Comments on any further information and submissions received at Deadline 2

by Anne Heard Interested Party reference 20054475

A. Comments on Springwell's response to Deadline 1 submissions REP2-023

Fig. 9 - Diagram showing the overlapping areas (infilled red) of the application site (red line) and the former Temple Bruer Estate (blue). Also identified are the heritage assets within the former estate boundary.

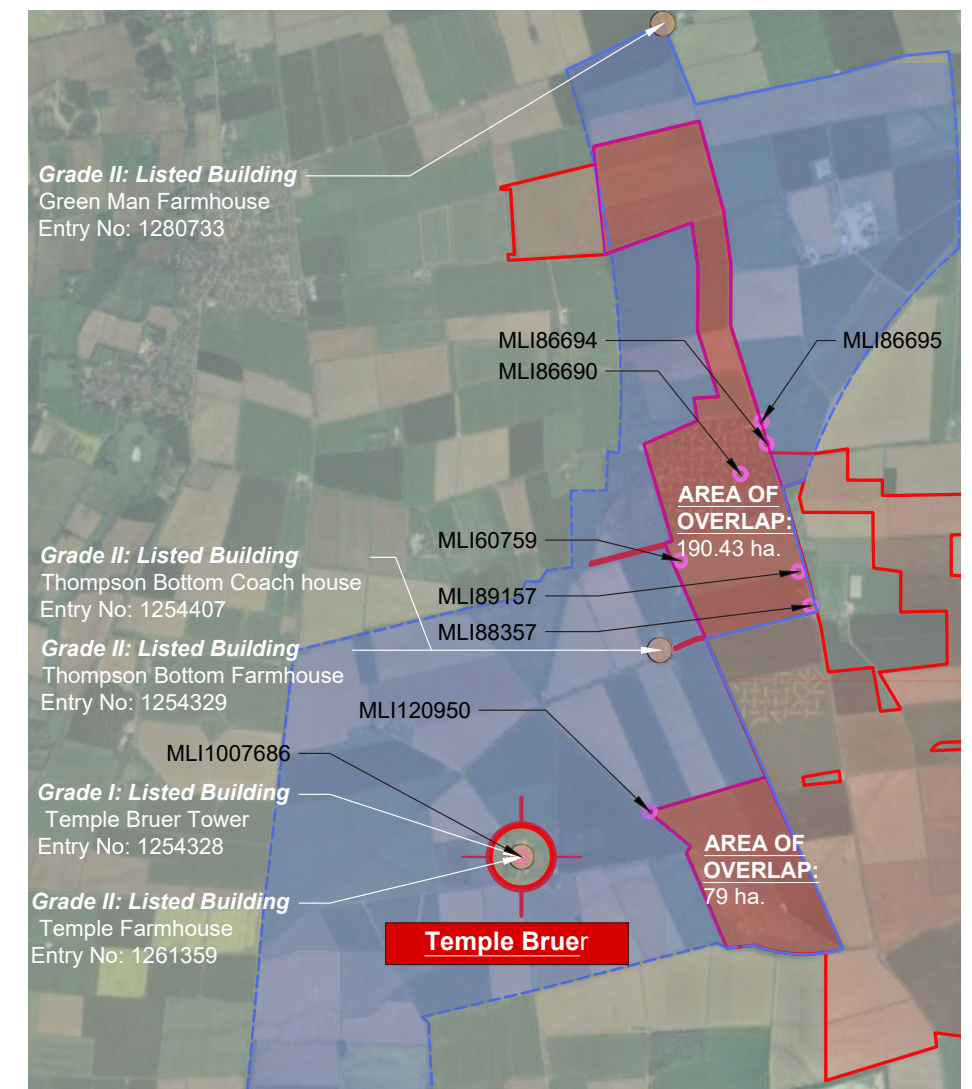
As can be seen in Figure 9, the application site overlaps a large area of the former Knights Templar Estate. The blue area denotes the former estate, with the red areas being the overlap with the application site (i.e. a total of nearly 270ha). Currently, these areas feature open farmland and are therefore representative of the historic rural character. The application site therefore currently contributes to understanding the historic relationship between the assets and the wider estate.

Fig. 12 - Diagram showing the application site overlaid on the designed landscape

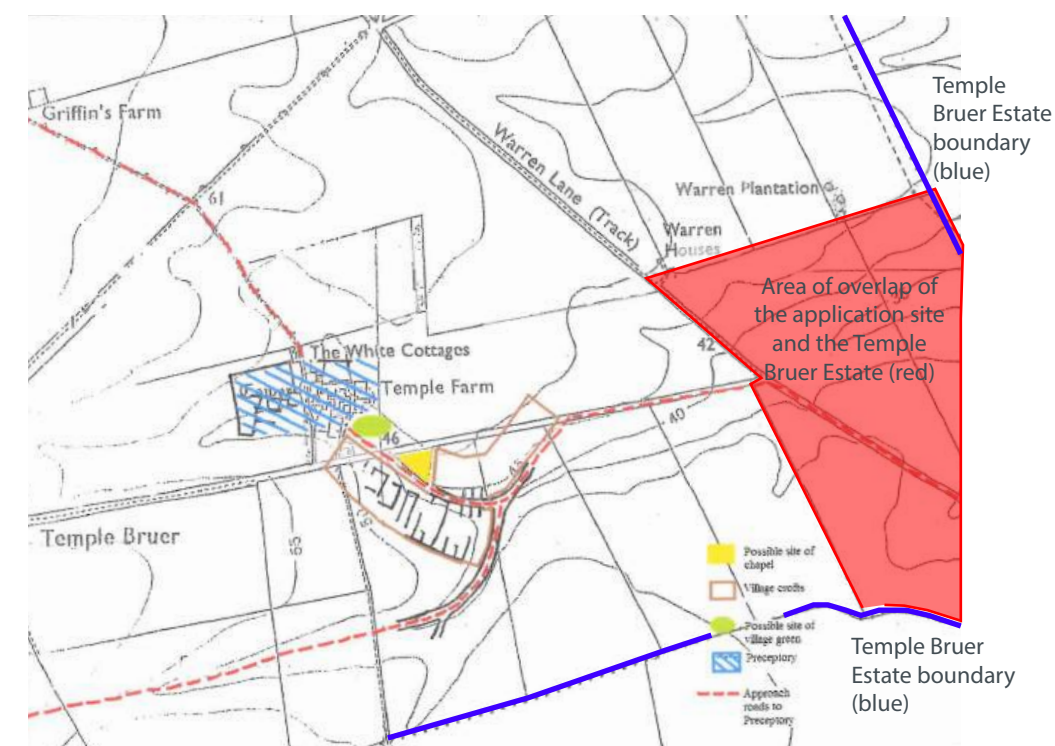
Many of these historic routes remain evident today, either as roads, footpaths or parish boundaries. Those which are located within the application site boundary and former Temple Bruer Estate are identified in Figure 12 (area shaded red).

Fig. 13 - Diagram showing the proposed development to be sited within the 'overlap' area

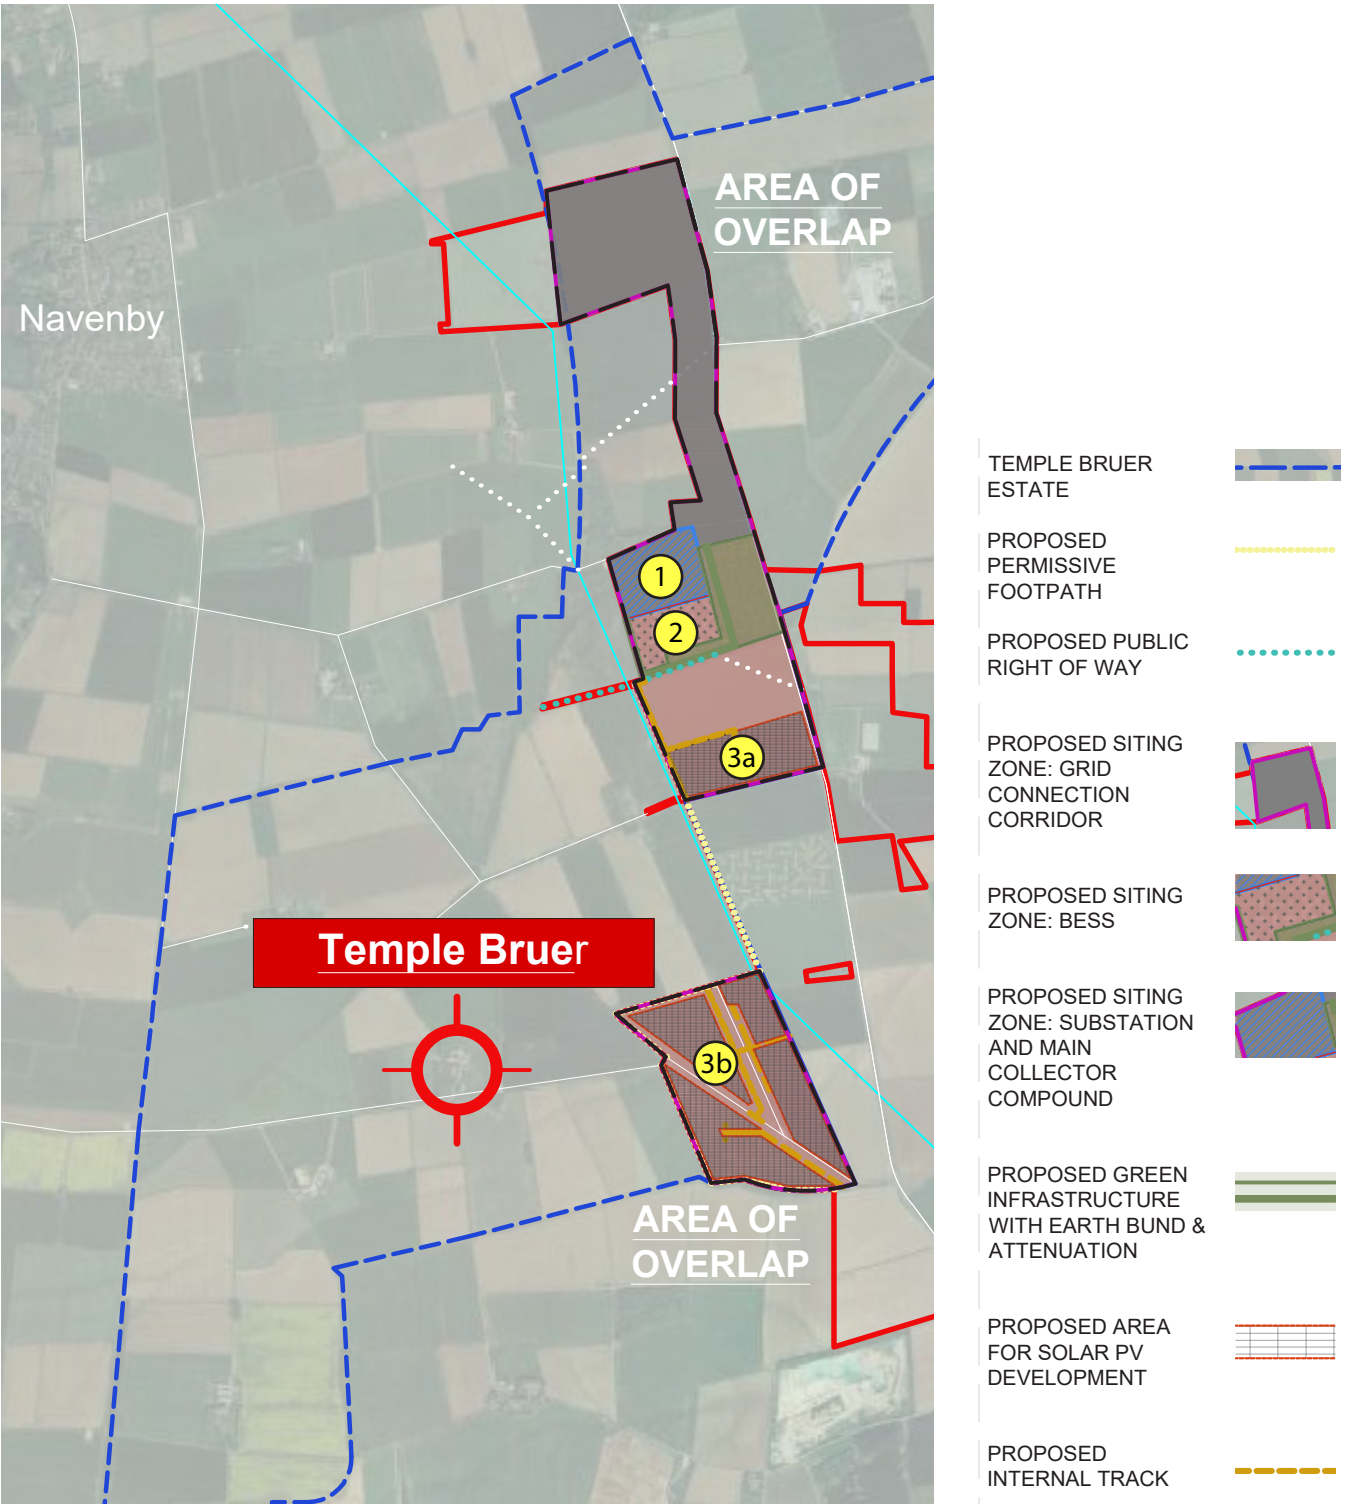
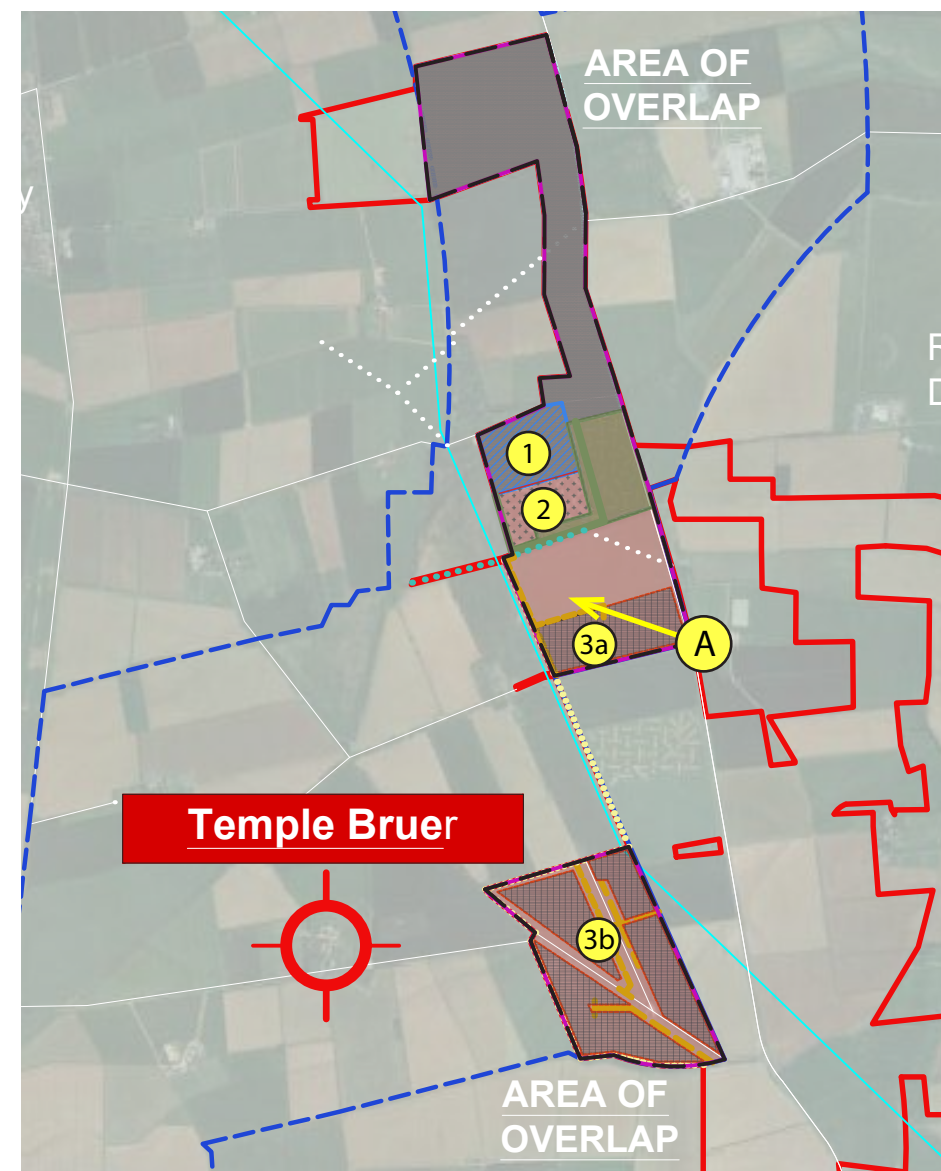
These works are identified on Fig. 13.

Viewpoints have been considered where the proposed development impacts these overlapping areas of land. Not all viewpoints feature the Preceptory tower, however the views are still considered relevant due to the experiential aspect of the moving through the historic landscape that still forms an integral part of the Temple Bruer story and therefore understanding.

Fig. 15 - Viewpoint B indicating area to be affected by development

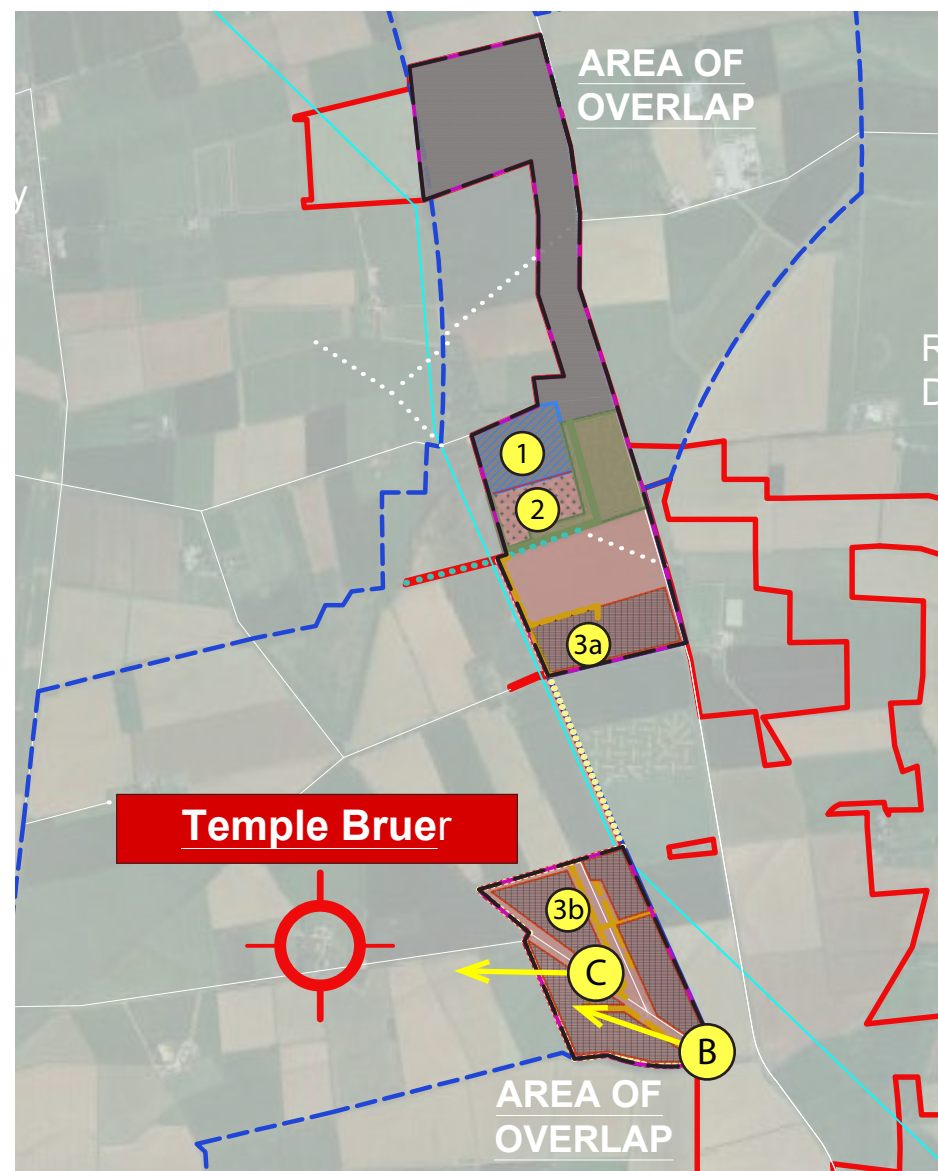
This view has been selected because it is located on a historic approach to the Preceptory, within the Templar Designed Landscape. Its potential impact on the significance of the Temple Bruer site has not been sufficiently assessed in the submitted ES.
